Optimization Review
Sidney and Richardson Hill Road Landfills
Delaware County, New York

OPTIMIZATION EVALUATION

Report of the Optimization Evaluation
Site Visit Conducted at the Sidney and Richardson Hill Road Landfill Superfund Sites
August 23, 2011

Final Report
April 4, 2012

Figure 3.1 - Richardson Hill Road Landfill extraction trench and expected capture zone.

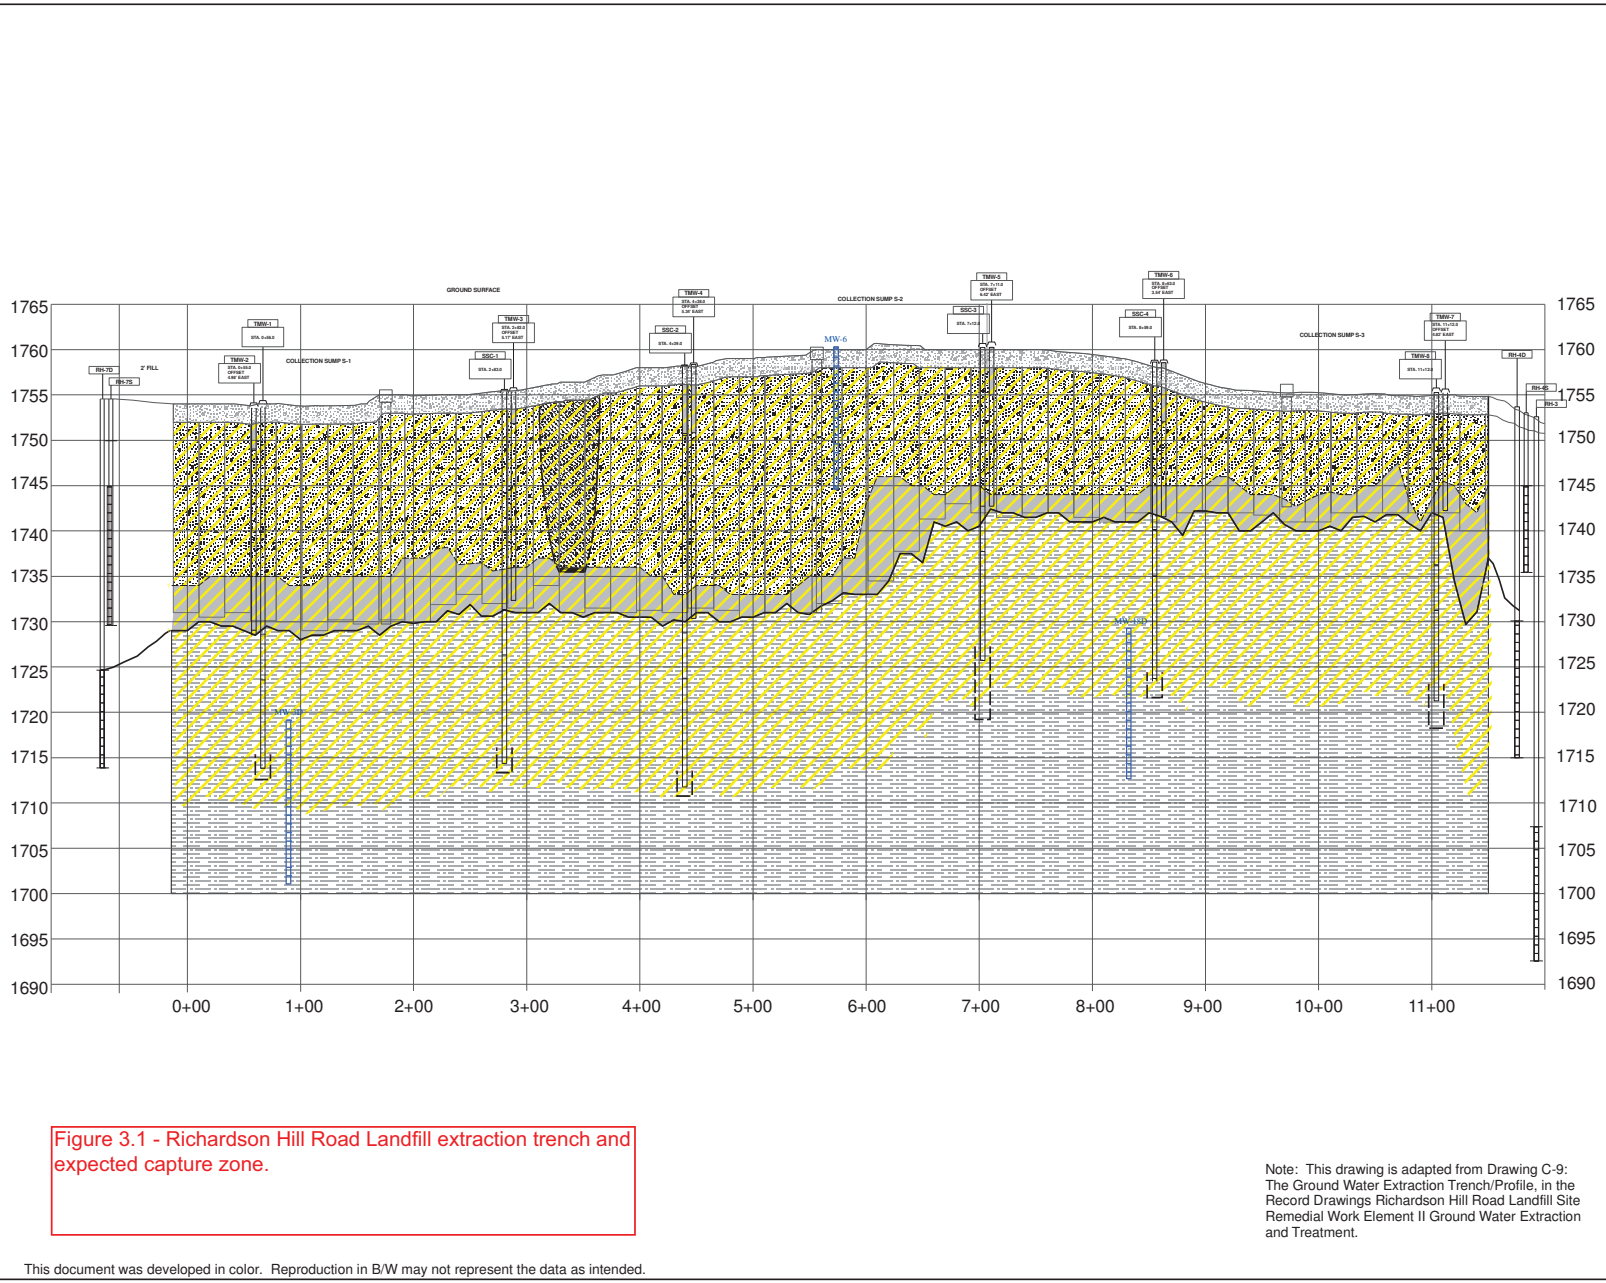
The extraction trench is located between monitoring wells TMW-01/TMW-02 and TMW-07/TMW-08, as illustrated on Figure 2-2 (see Attachment A). The trench is approximately 1,150 feet long, 3 feet wide, and extends to bedrock at an elevation ranging from 1728.5 to 1742.4 feet above mean sea level (amsl). The northern half of the trench is an average of 10 feet deeper than the southern half. The trench is keyed a minimum of 2 feet into dense till and bedrock. An 80-mil HDPE barrier wall was installed on the downgradient side of the trench before it was backfilled with clean stone. Three sumps (S1 through S3) consisting of vertical 24-inch perforated pipe with submersible pumps are installed to pump groundwater to the GWTP. Each pump is turned on or off depending upon the water surface elevation in the corresponding sump. (Each pump is controlled independently by a separate level measuring system in the sump.) Each sump also includes a dilute acid feed line intended to limit iron precipitation. A single underground pipeline carries the combined flow from the three sumps to the GWTP. A flow meter at the GWTP measures combined flow and reports it to the system computer. Figure 3-1 (see Attachment A) depicts the trench construction and the anticipated capture zone.

The groundwater modeling study conducted in 2000 to preliminarily evaluate an extraction trench design suggested that 30 gpm would be required along a 950-foot trench to provide capture 25 feet into bedrock and that a drawdown of 5 feet would provide that amount of flow during typical conditions. The actual trench is 1,150 feet long, a drawdown of more than 5 feet is achieved in the in-trench monitoring wells, but extraction rates averaged approximately 20 gpm during 2010. Therefore, overall actual flow is lower than the modeled flow.

Figure 5-1. Groundwater Elevations Richardson Hill North Area (Arrows indicate direction of gradient)

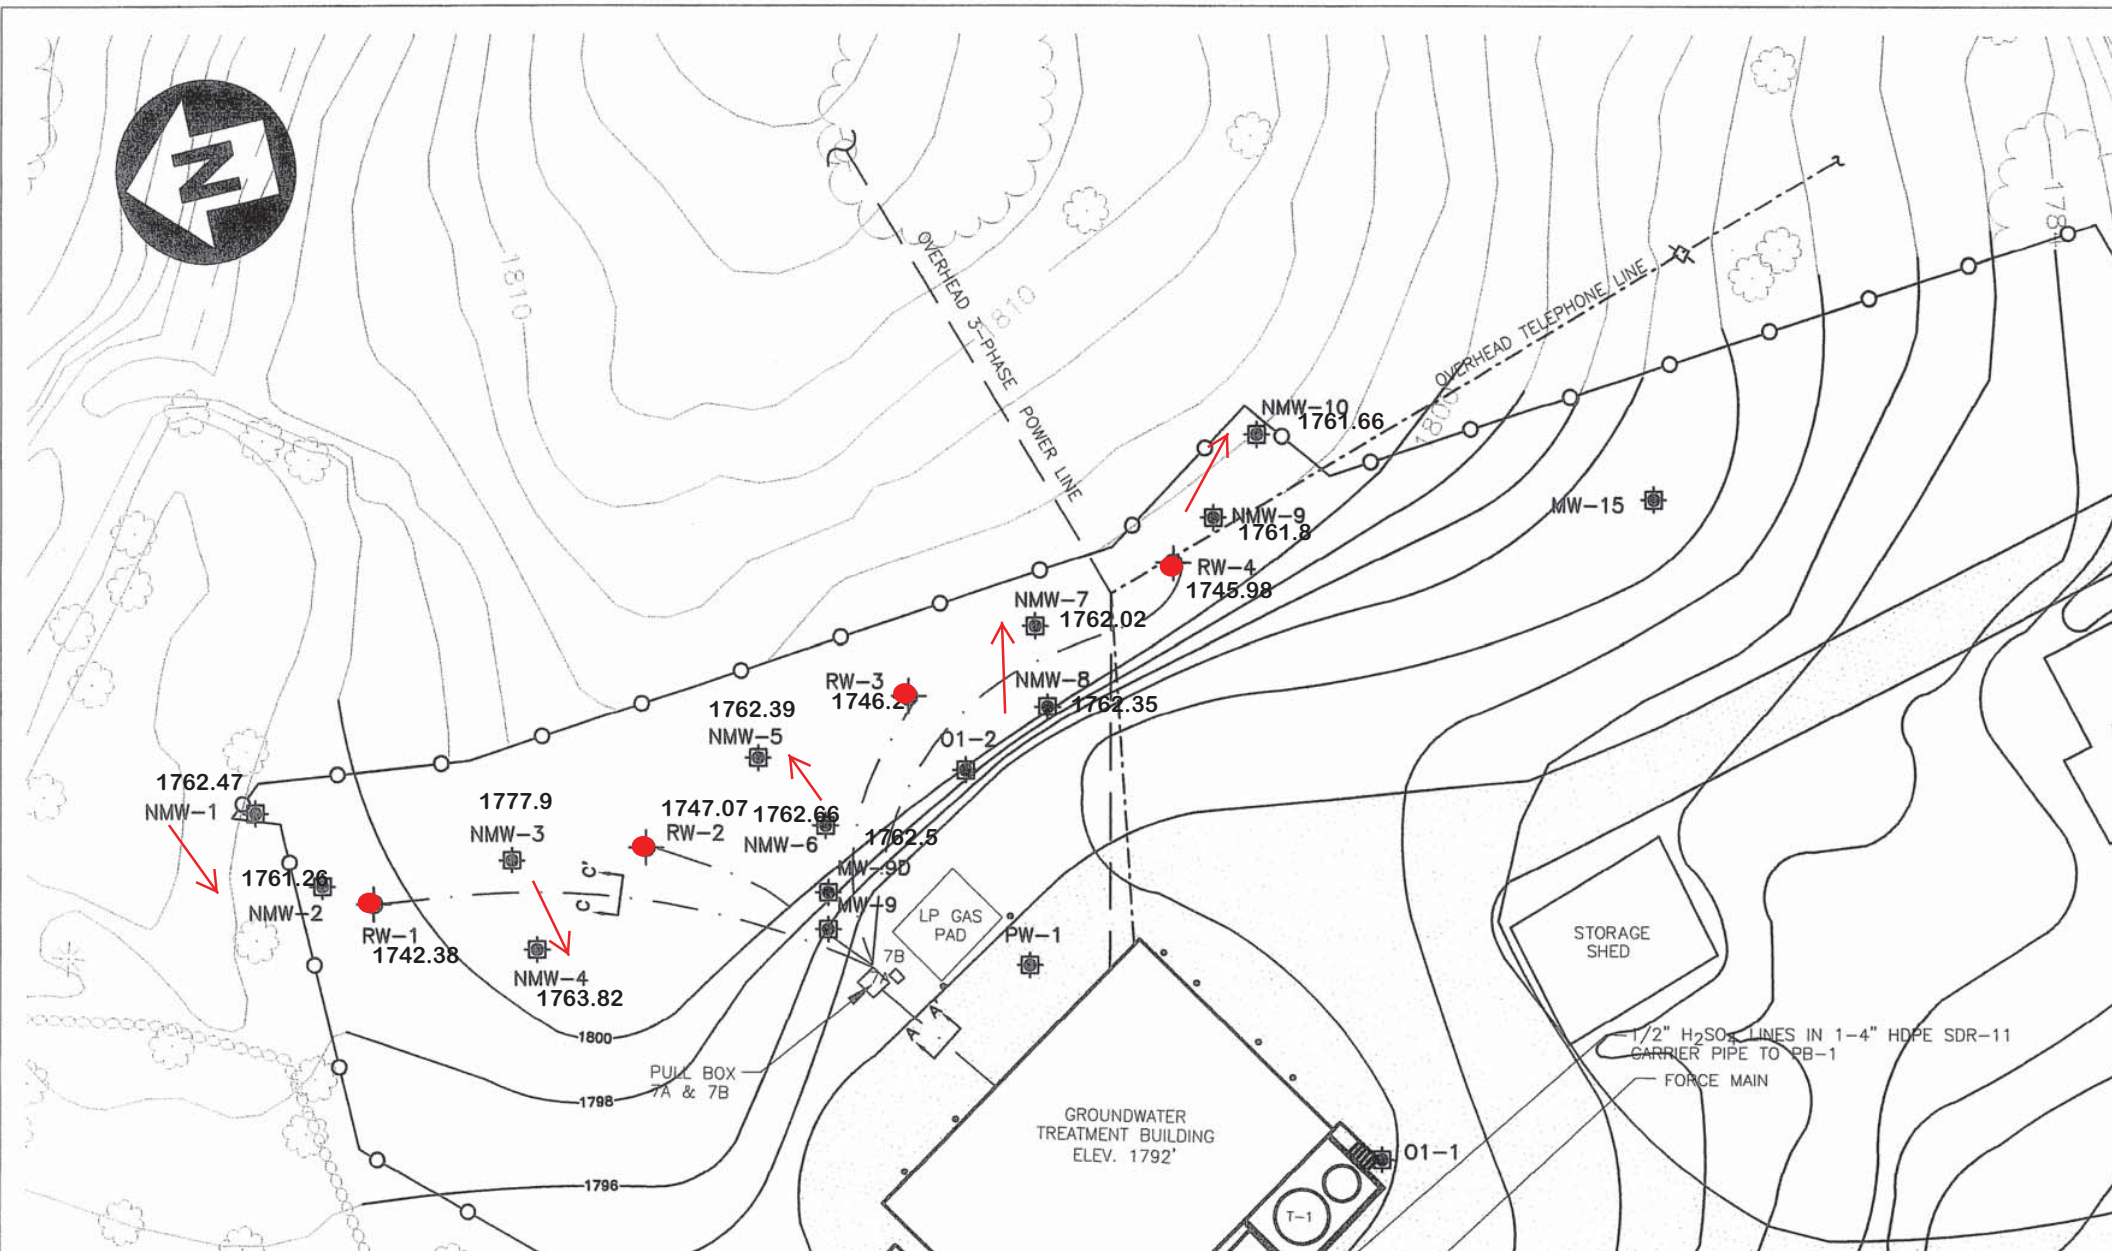
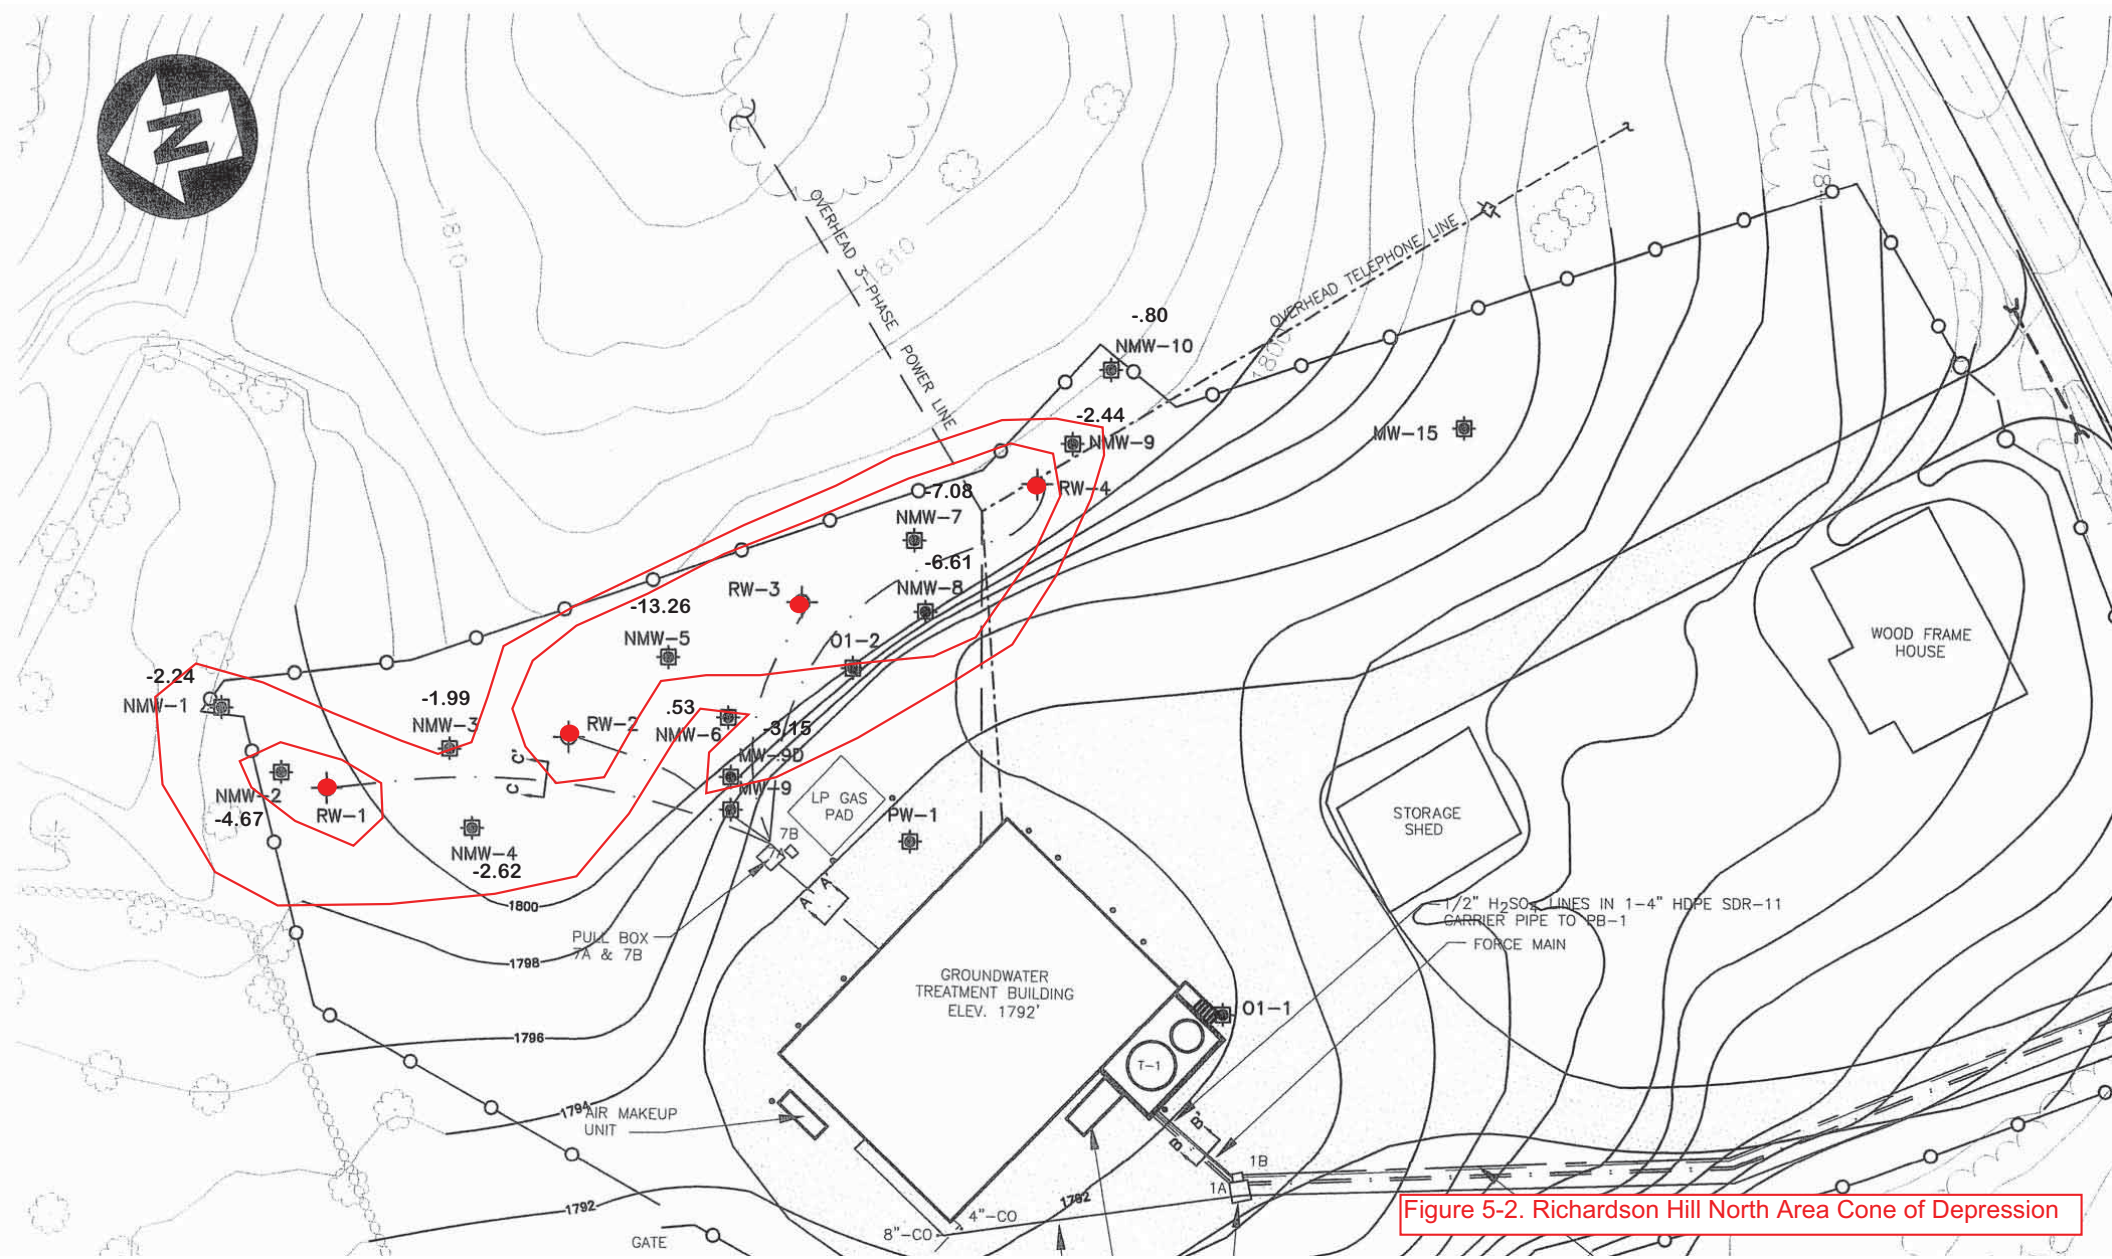
Groundwater elevation and cone of depression maps for the North Area groundwater extraction wells are shown in Figures 5-1 and 5-2 (see Attachment A). The performance objective is at least 1 foot of drawdown in the North Area monitoring wells compared with the non-pumping conditions noted in the O&M plan. This is generally being achieved (NMW-9 is the only exception); however, it should be noted that the “target levels” reported in Table 2 of the 2009 RHRL Annual Report and Table 10 of the 2010 RHRL Annual Report are the non-pumping conditions based on the table on page 3-8 of the O&M plan. The actual “target levels” are 1 foot lower than the non-pumping conditions specified on page 3-8 of the O&M plan. Even with this adjustment or correction, the criteria are being met. As discussed in the section on plume capture for Sidney Landfill, it is unclear whether these wells are providing the level of capture anticipated despite meeting performance criteria. The 2000 modeling study suggested that the four wells would pump a total of 10 gpm. During 2010, the average total pumping rate was approximately 2.5 gpm.

When the water levels in the North Area are reported, the target levels that are provided for comparison should be 1 foot lower than the non-pumping conditions presented in the O&M plan.

Figure 5-3
cDCE Shallow Bedrock Plume

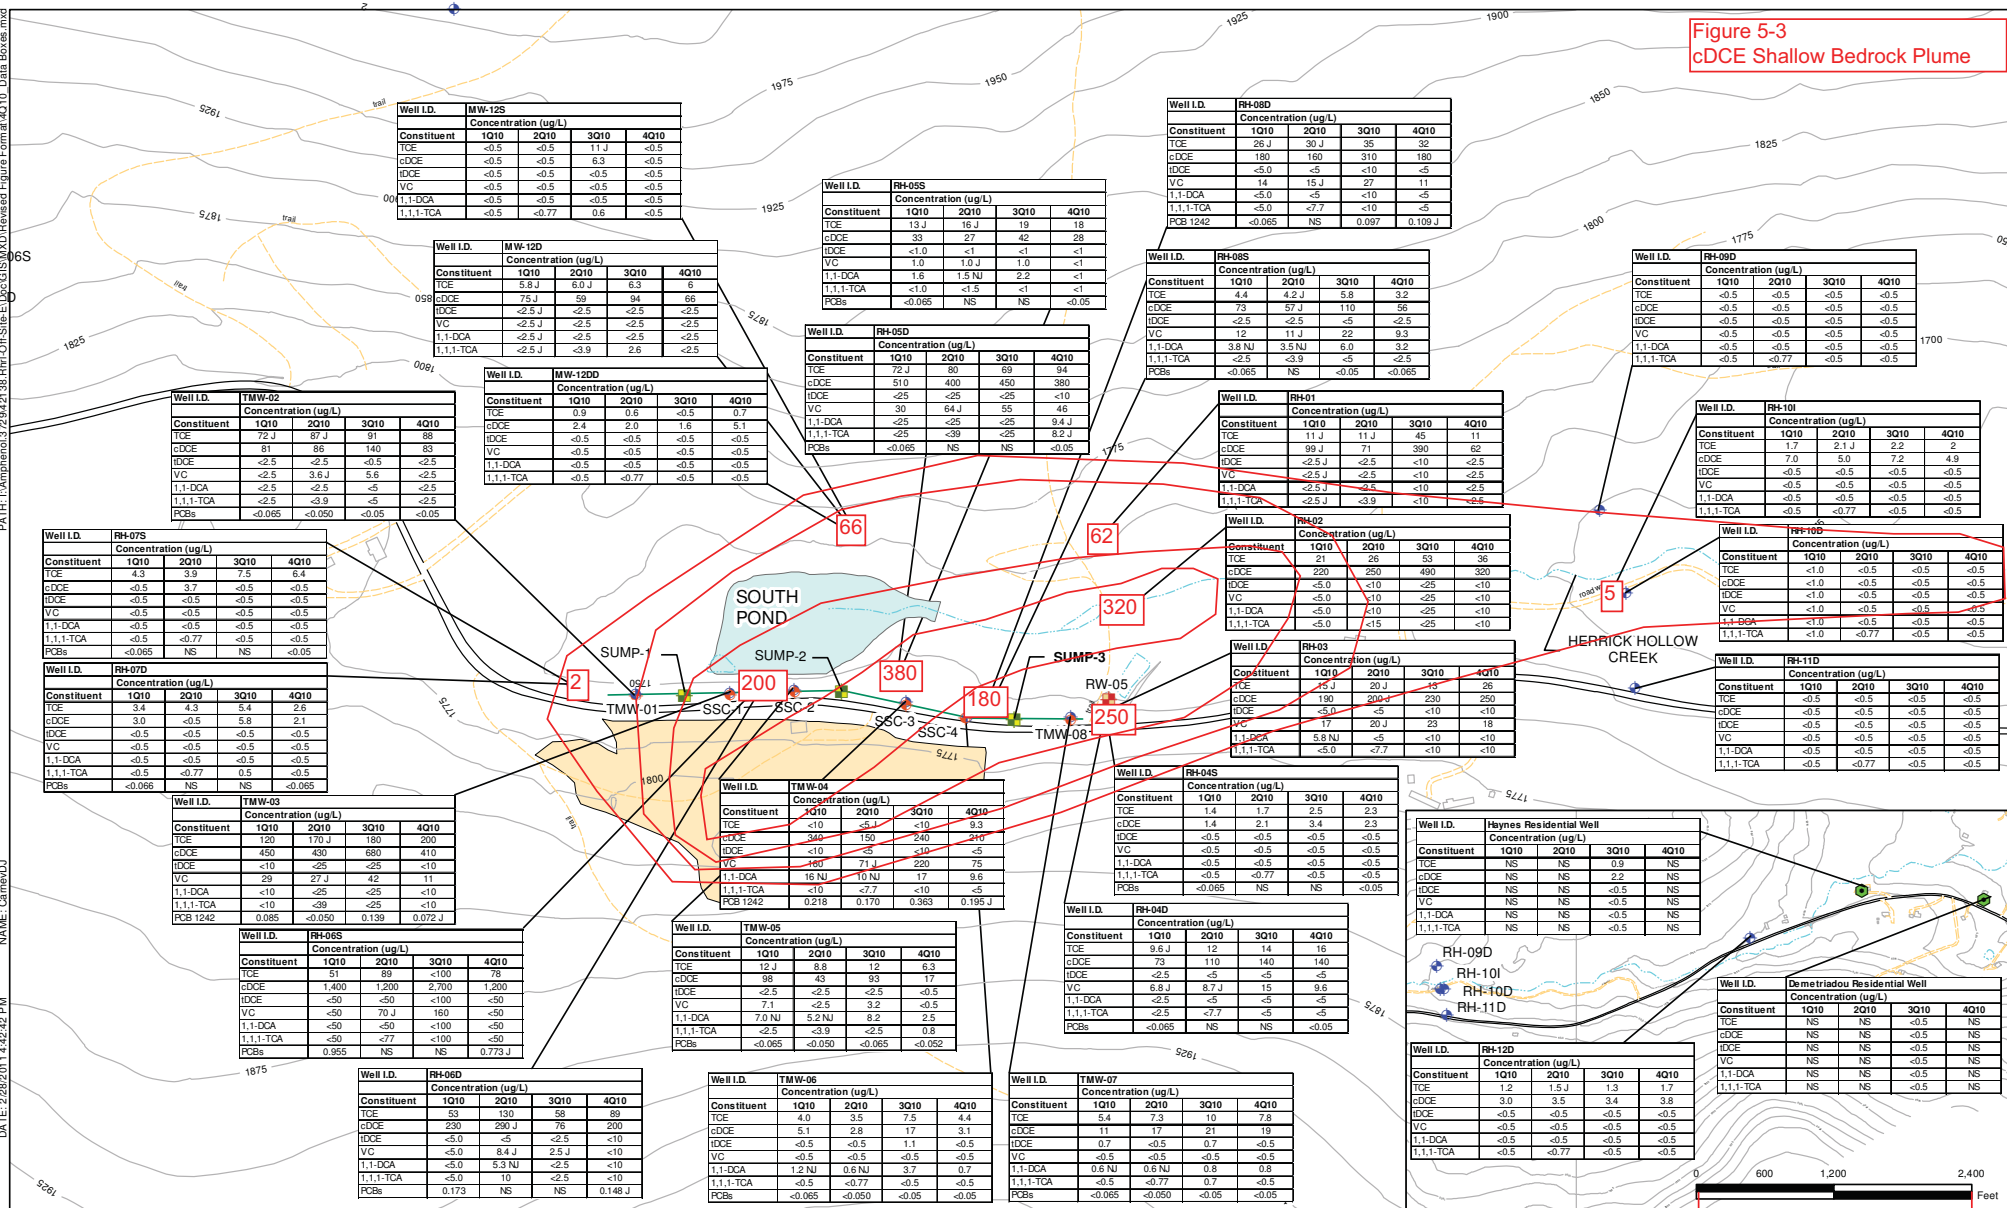
The groundwater plume in the upper bedrock unit from the RHRL has migrated to the southeast and then trends more southerly along the Herrick Hollow Creek valley, extending approximately 6,000 feet south of South Pond (Figure 5-3, Attachment A). The core of the plume passes through monitoring wells RH-05D and RH-02. Given the age of the landfill and the relatively slow groundwater velocities, this plume was established before the extraction trench was installed.
